Subject: Duke Energy Corporation  
Catawba Nuclear Station, Unit 1  
Docket Number 50-413  
Request for Relief Number 05-CN-001  
Reply to NRC Request for Additional Information

REPLY TO NRC REQUEST FOR ADDITIONAL INFORMATION

Catawba Nuclear Station, Unit 1 Relief Request 05-CN-001 -  
Request for Additional Information

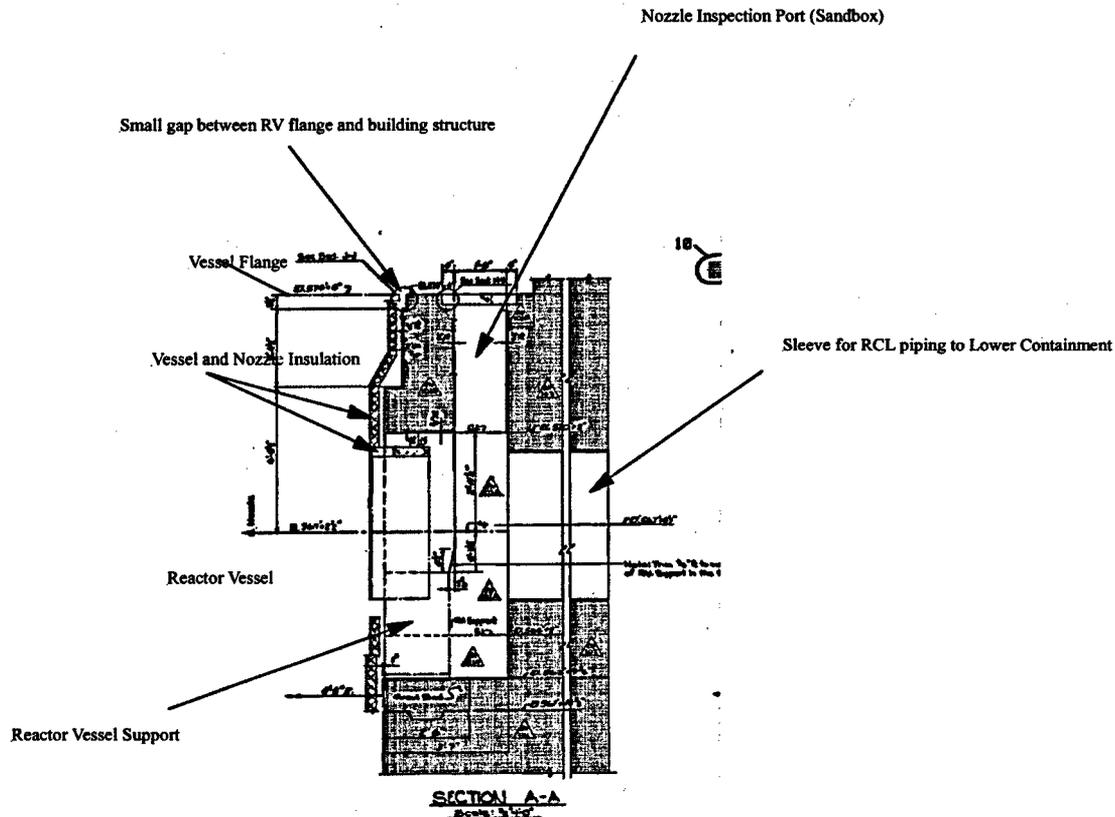
2.2.3 The submittal adequately explains the interferences caused by the RPV insulation and biological shield wall, and states that an area approximately 71-inches long by 36-inches high could not be visual VT-3 examined on the vessel side of each of the subject supports, even with remote camera systems or mirrors. Please report the percentage of the ASME Code examination boundary actually obtained for each of these supports. In addition, discuss whether access to the vessel side of these supports is available by remote means after the refueling canal has been drained and the refueling cavity/RPV seal deflated or removed.

In light of recent events, the potential for boric acid to cause severe wastage on carbon steel components is of significant concern to the staff. Several generic letters and bulletins have been issued to address the

potential for degradation due to boric acid in contact with carbon steel (Generic Letter 88-05, Bulletin 2003-02, etc.). Because the vessel side of the subject supports is not currently being visually examined, provide a basis to ensure that wastage is not on-going in these areas. Additionally, discuss whether the subject RPV supports should be examined more frequently than once every 10 years, as is required by ASME Code, given these concerns.

Approximately 50% of the support was examined. A pole camera was inserted in each of the four nozzle inspection ports (sandboxes) from above. The entire support was inspected from the outboard side. However, there is no access to the inboard side of the support.

There is no direct access to the vessel side of these supports with the refueling cavity seal removed. The drawing below shows the general configuration and the very limited space (approximately 2") between the reactor vessel and the concrete building structure. The vessel insulation in the gap between the reactor vessel and the building structure limits the access for a borescope or other optical device through the refueling cavity seal gap. Although a small gap is present, there remain two horizontal offsets and the nozzle insulation that preclude an effective visual inspection of this side of the support. The vertical distance (8 to 10 feet below the flange) combined with the horizontal offsets and existing vessel and nozzle insulation prohibit an effective remote visual examination.

The reactor vessel supports are located on four of the eight reactor vessel nozzles. The only potential welds (see note below) that represent a leakage source that could degrade the support from the inboard vessel side are the vessel nozzle to shell welds and the circumferential vessel flange to shell weld. These low alloy steel welds are volumetrically examined every ASME XI inspection interval. Based on these recent successful inspections with no reportable indications and PWR operating experience, a leak at these locations is extremely unlikely. Leakage during refueling activities through the cavity seal is possible but based on corrosion rates and the condition of the support on the sandbox side subjected to similar leakage, there is no concern with any degradation of the structural capacity of the support.
